BEDFORD REGIONAL WATER AUTHORITY
SMITH MOUNTAIN LAKE WTP &
LAKES TO FOREST WATER LINE EXTENSION
LEGEND, DETAILS AND SCHEDULES

**BEDFORD REGIONAL WATER AUTHORITY
SMITH MOUNTAIN LAKE WTP &
RAW WATER PUMPING STATION / INTAKE
PLUMBING
MEMBRANE BUILDING OPERATING FLOOR
DRAINAGE AND VENT PIPING PLAN**

BEDFORD REGIONAL WATER AUTHORITY
SMITH MOUNTAIN LAKE WTP &
RAW WATER PUMPING STATION / INTAKE
PLUMBING
MEMBRANE BUILDING TRENCH
FLOOR DRAINAGE PLAN

OPERATING FLOOR DRAINAGE & VENT PIPING PLAN
SCALE: 1/8" = 1'-0"

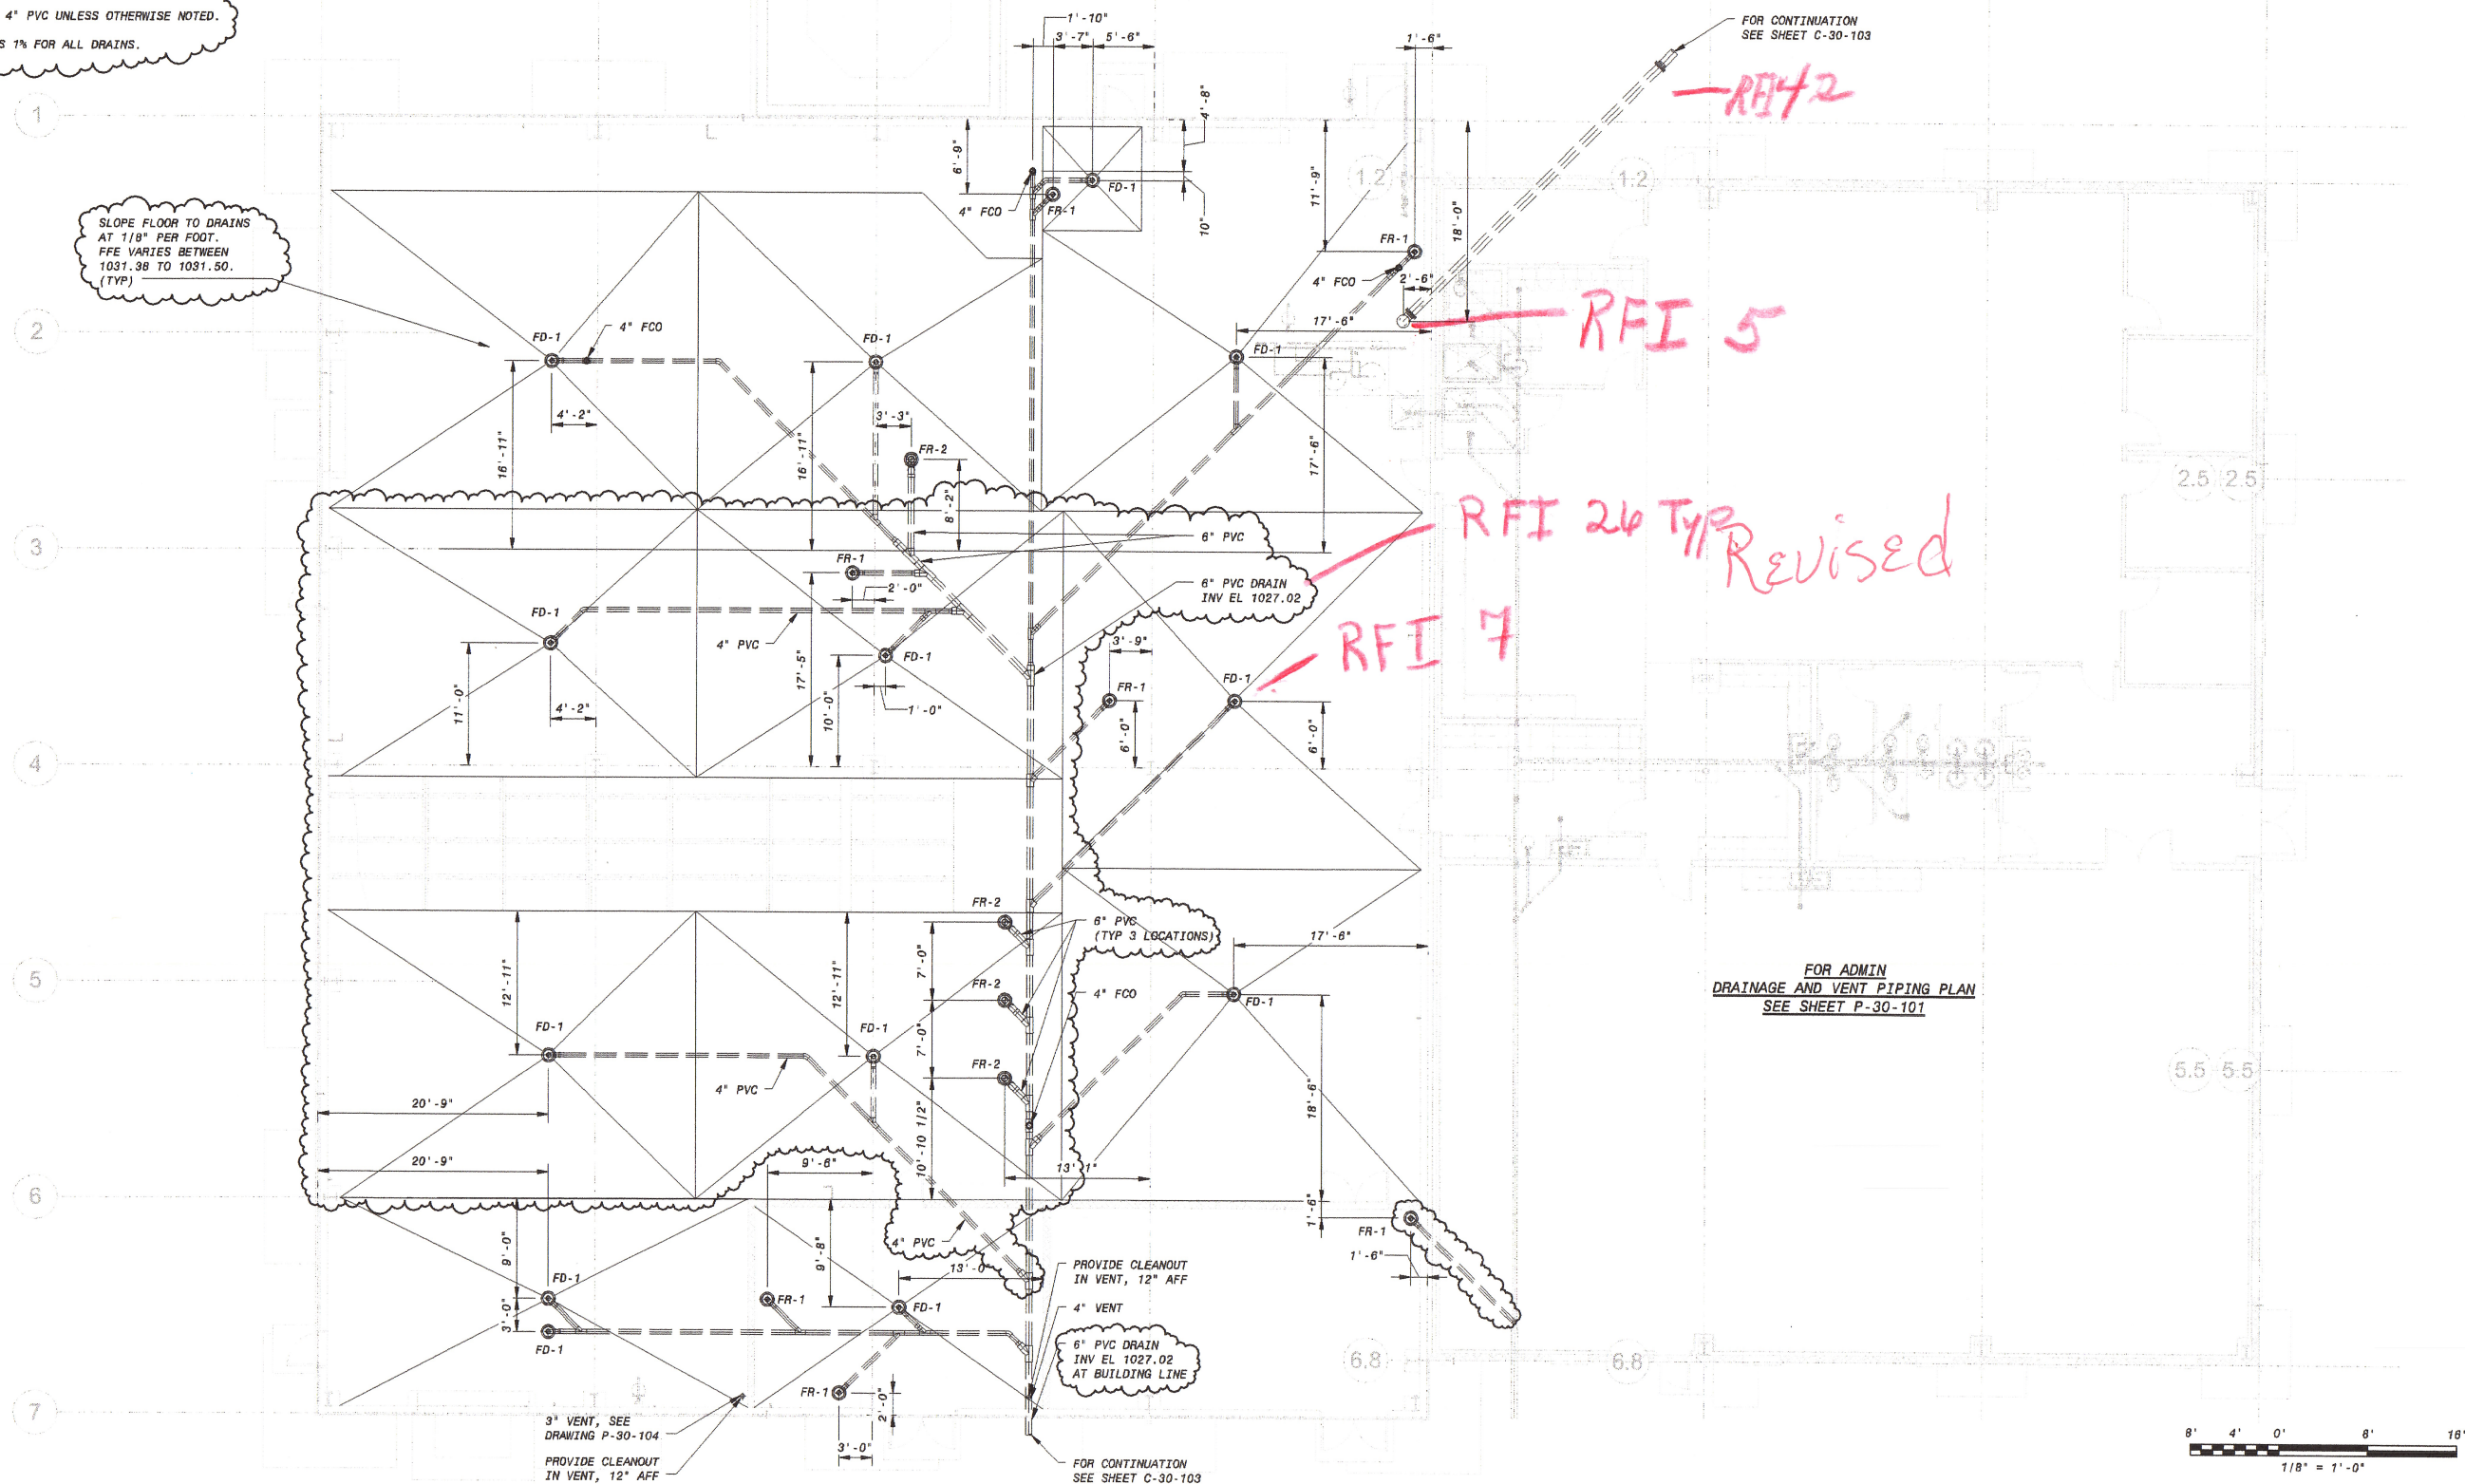
ECN 9

—RE42

RFI 5

RFI 24 Type Revised

RFI 7
